## REVISED RESPONSE TO REQUEST FOR ADDITIONAL INFORMATION

### APR1400 Design Certification

Docket No. 52-046

**RAI No.:** 557-9199  
**SRP Section:** 03.08.05- Foundations  
**Application Section:** Tier 2, Section 3.8.5 and Tier 1  
**Date of RAI Issue:** 12/01/2017

Figure 2.2.2-1 Emergency Diesel Generator Building Block Section

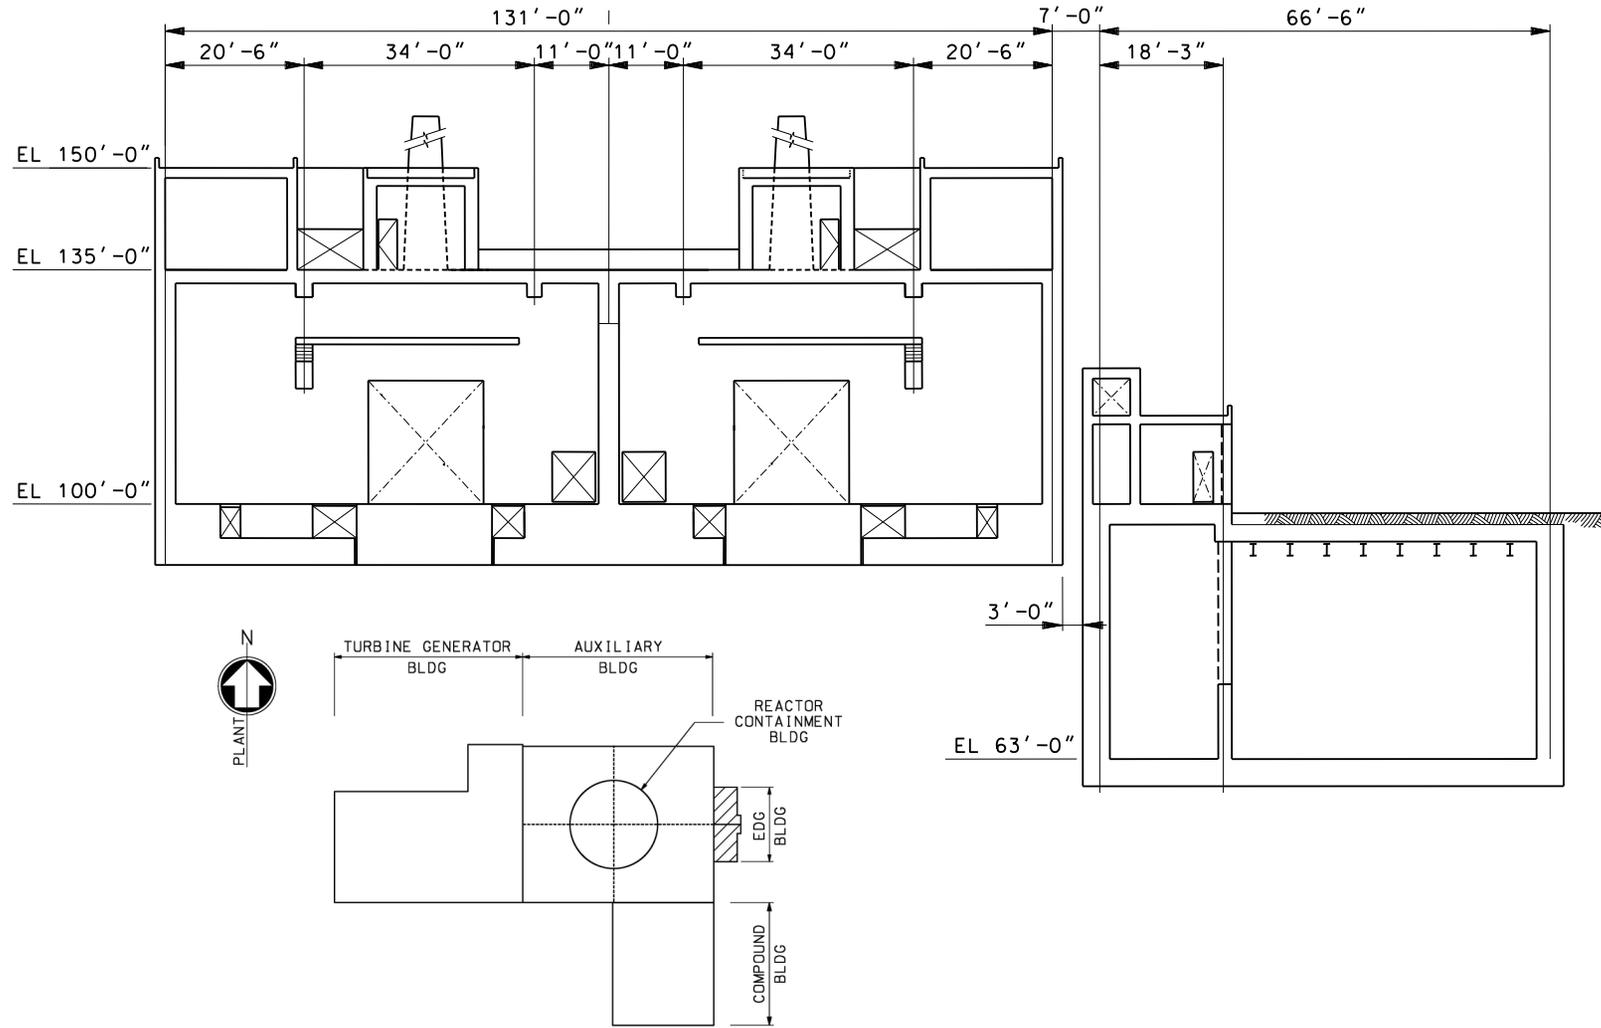
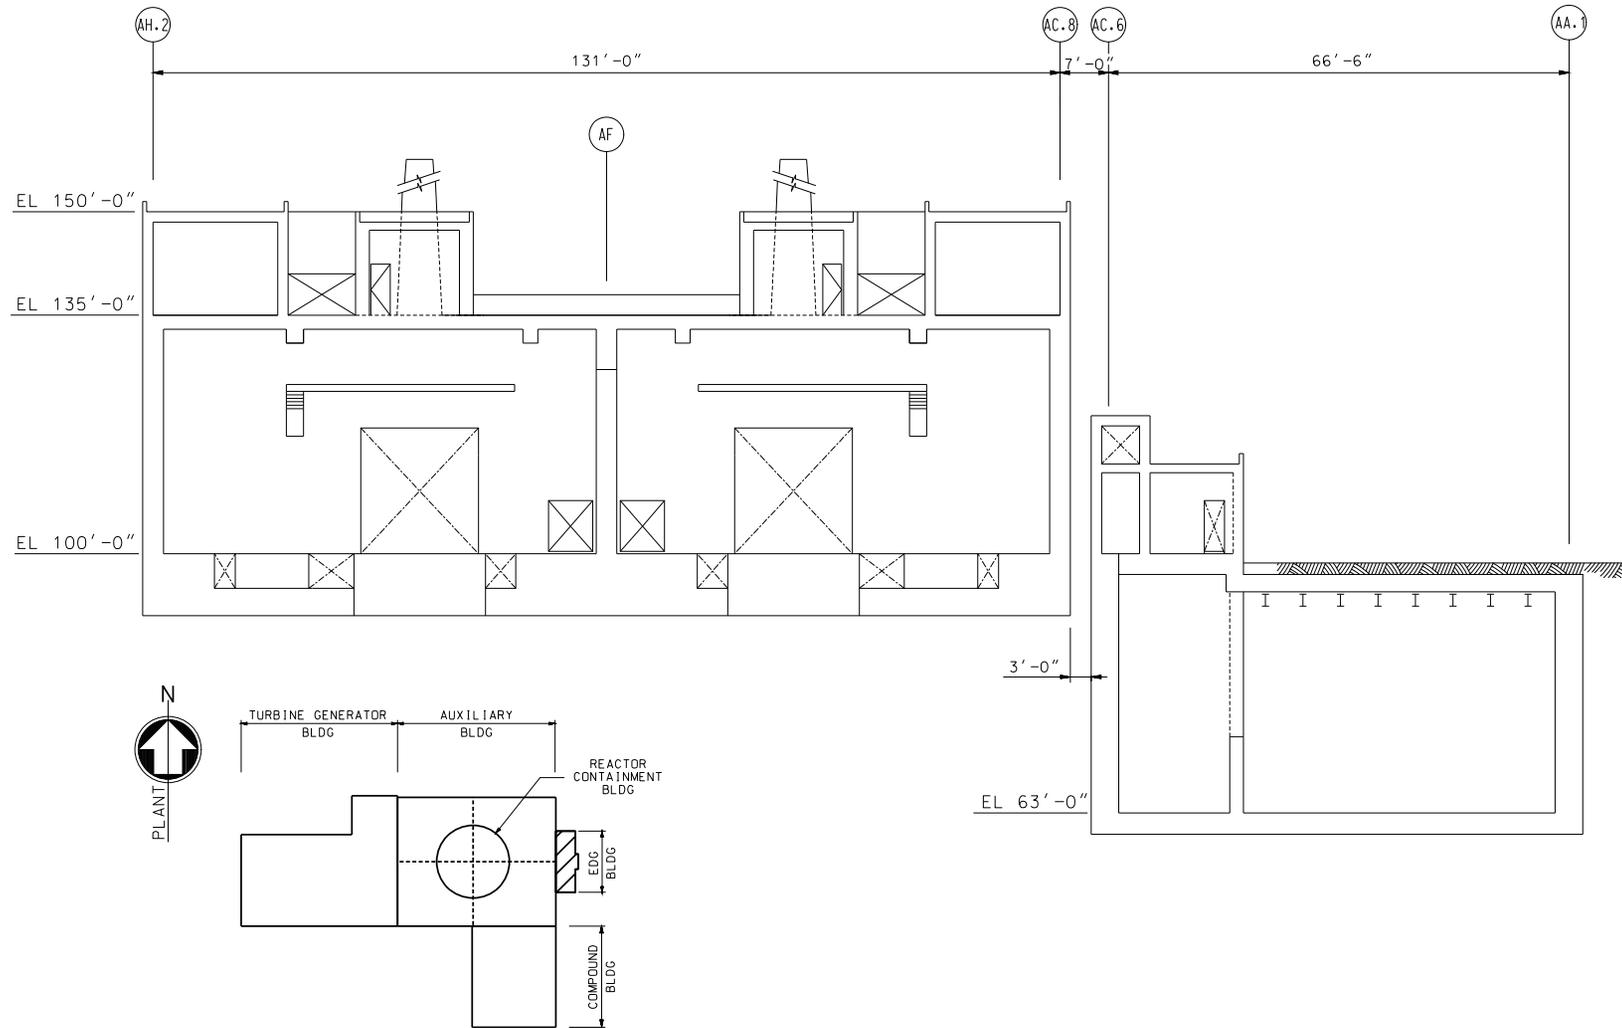
The dimensions and elevations of the EDG building block are as described in Table 2.2.2-1, Figure 2.2.2-1 and Figure 2.2.2-2.

3. <del>The key dimensions of the EDG building block are as described in Table 2.2.2-1, Figure 2.2.2-1, and Figure 2.2.2-2.</del>	3. <del>Inspection will be performed to verify that the as-built wall and slab thickness conform to the structural configuration.</del>	3. <del>A report exists and concludes that the EDG building block as-built wall and slab thickness conform with the structural configuration as described in Table 2.2.2-1, Figure 2.2.2-1, and Figure 2.2.2-2.</del>

The tolerances for the dimensions in Table 2.2.2-1 and Figures 2.2.2-1 through 2.2.2-2 shall be in accordance with ACI 117(2010 edition) for concrete structures and ANSI/AISC 303(2010 edition) for structural steel members /structures. Any provisions in these codes which provide acceptance criteria for conditions when tolerances are exceeded shall not apply, but a licensee referencing the APR1400 DCD may deviate from the tolerances in these codes using alternative acceptance criteria, if these acceptance criteria are approved by the NRC. As-built dimensions will also be evaluated to verify compliance with the design bases and applicable codes and standards identified in Table 2.2.1-5.
